DOCKETED	
Docket Number:	23-AFC-02
Project Title:	Elmore North Geothermal Project (ENGP)
TN #:	250395
Document Title:	Elmore North Geothermal Project Data Adequacy Response Set 1
Description:	N/A
Filer:	Jerry Salamy
Organization:	Jacobs
Submitter Role:	Applicant Consultant
Submission Date:	5/30/2023 1:56:08 PM
Docketed Date:	5/30/2023

Data Adequacy Supplement

Elmore North Geothermal Project
(23-AFC-02)
May 30, 2023

Figure DA4.0-1a
Production Wells
Elmore North Geothermal Project
Imperial County, California

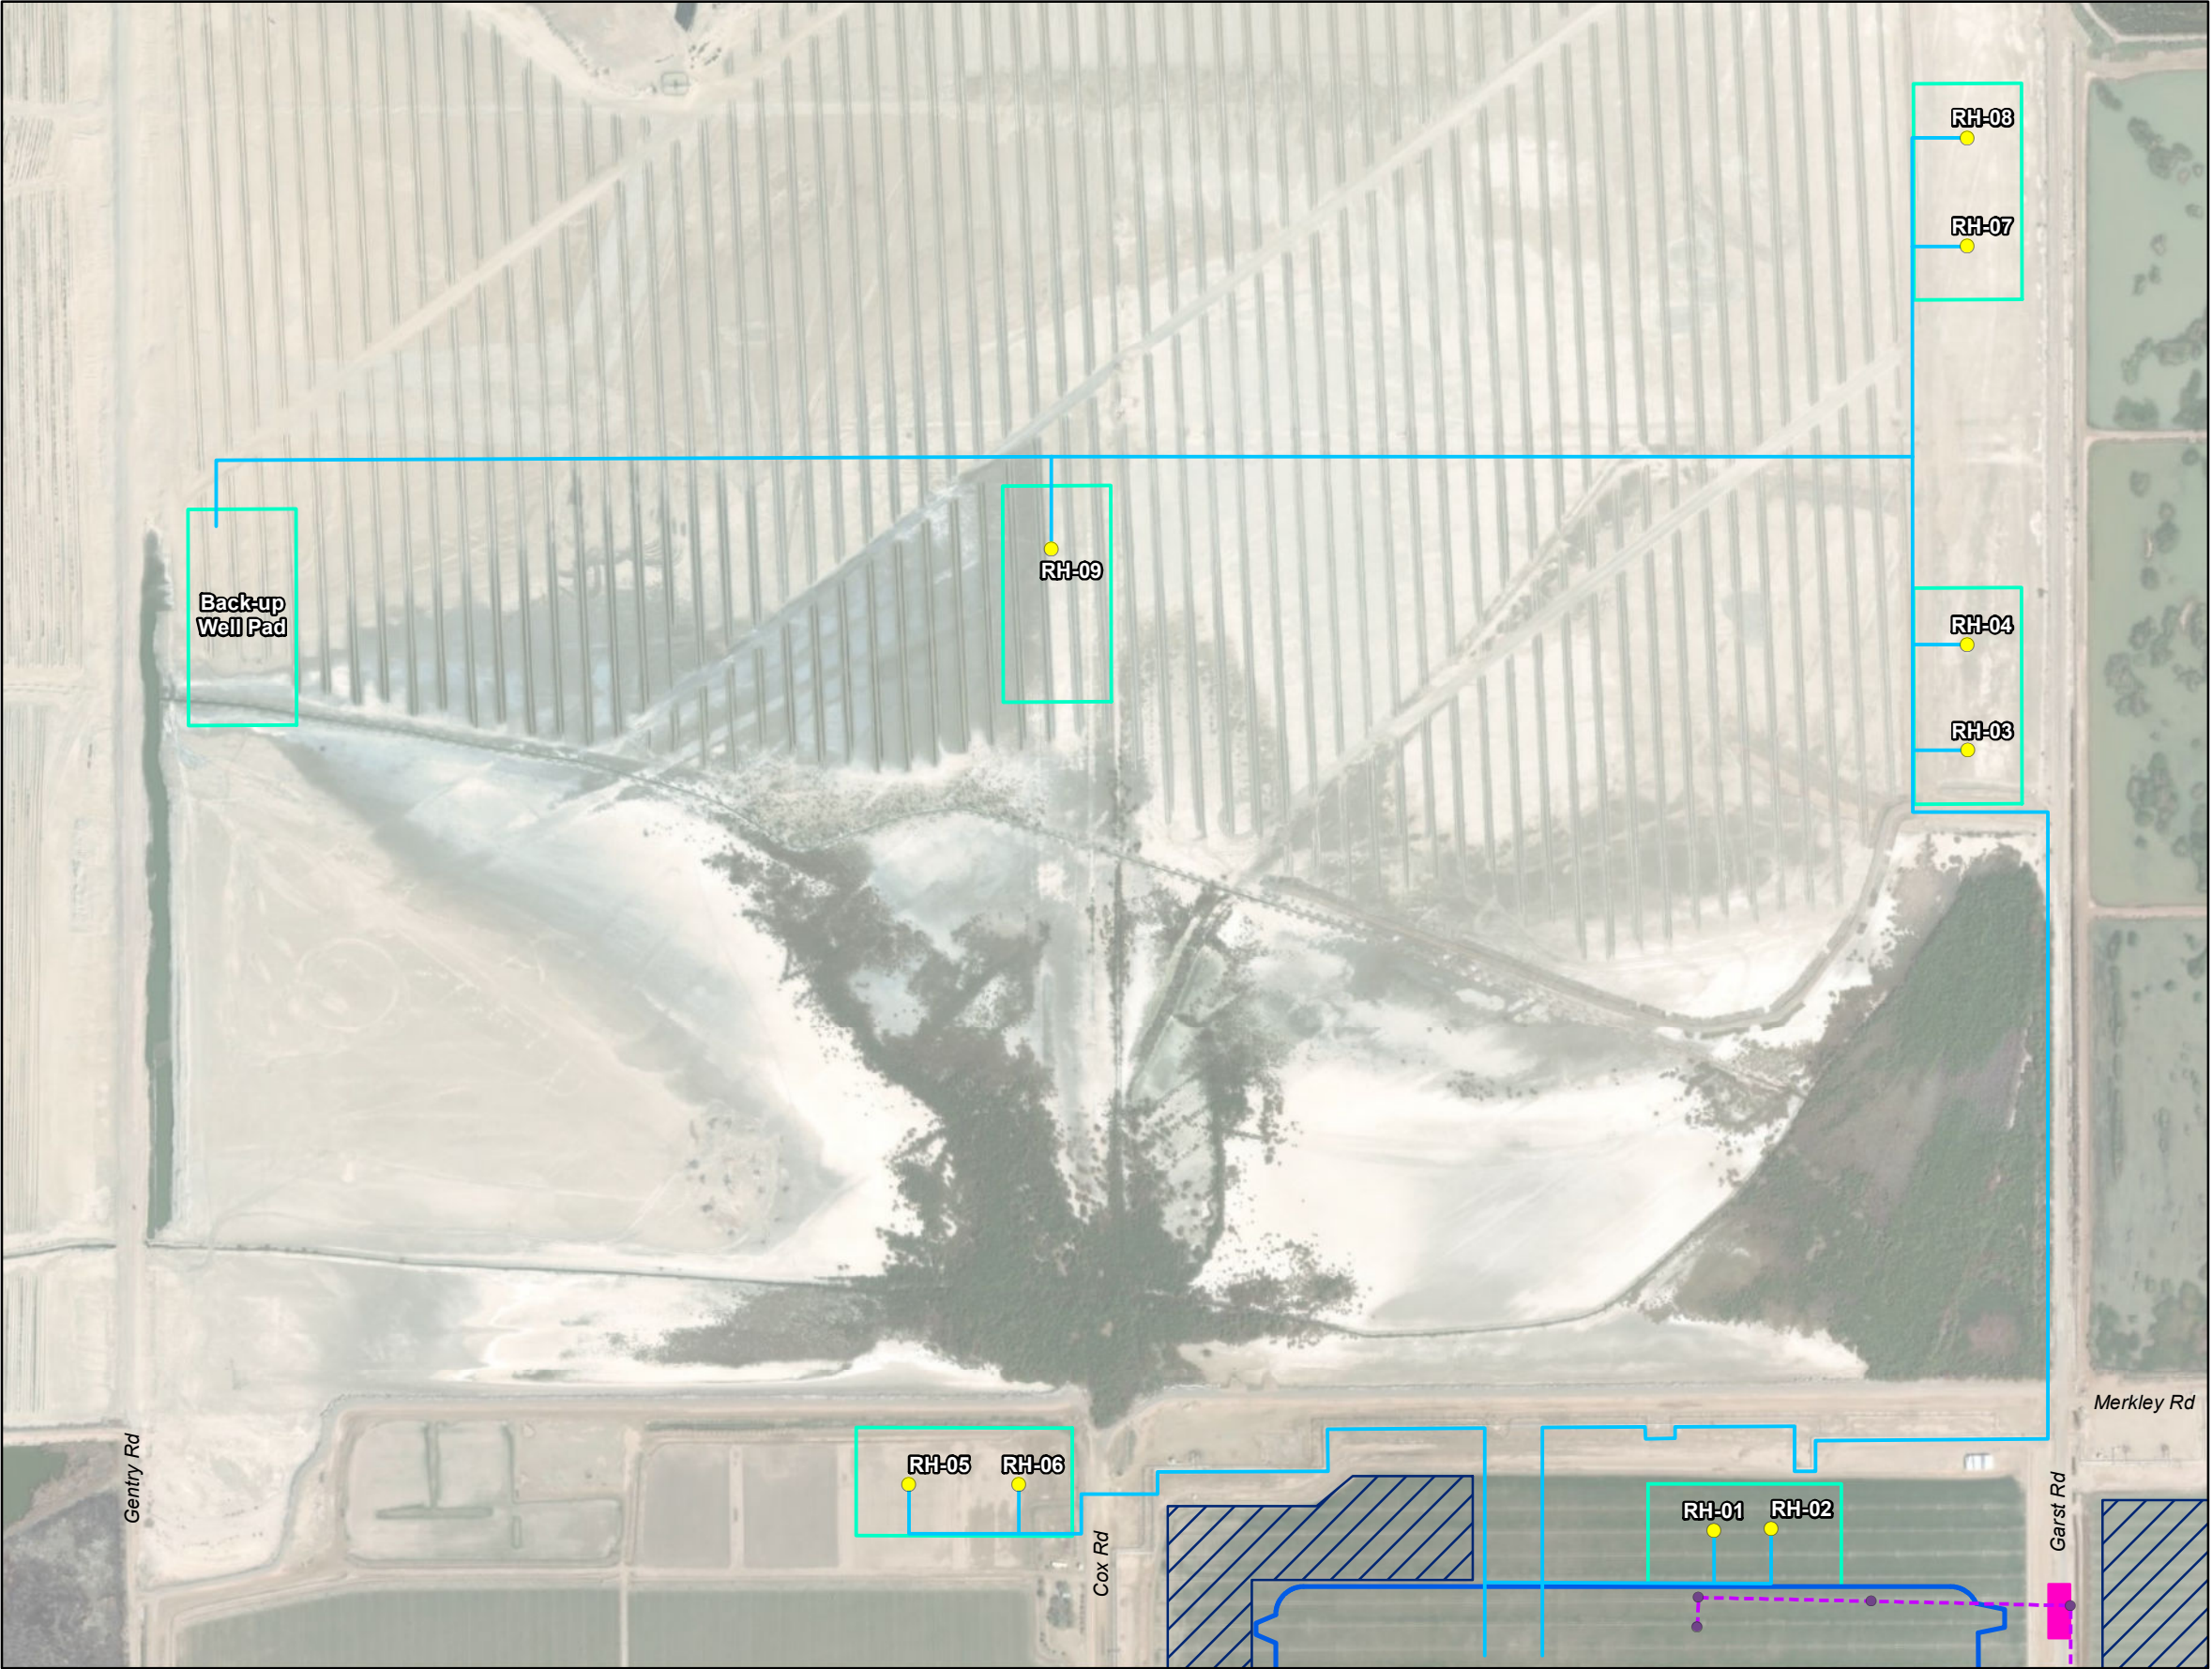
Detailed discussion with well numbers, of all wells and well pads, including production, injection, and make-up wells, along with diagrams at a suitable scale, should be included in the AFC, as part of the larger discussion of the geothermal leases and site selection, suggest 2.3.3 with discussion headings for each well type.

Response: Figure DA4.0-1a shows the five production well pads, backup well pad, and wells RH-01 to RH-09, at a suitable scale. The well pad with well RH-09 has sufficient space for an additional well to be added and two wells to the backup well pad.
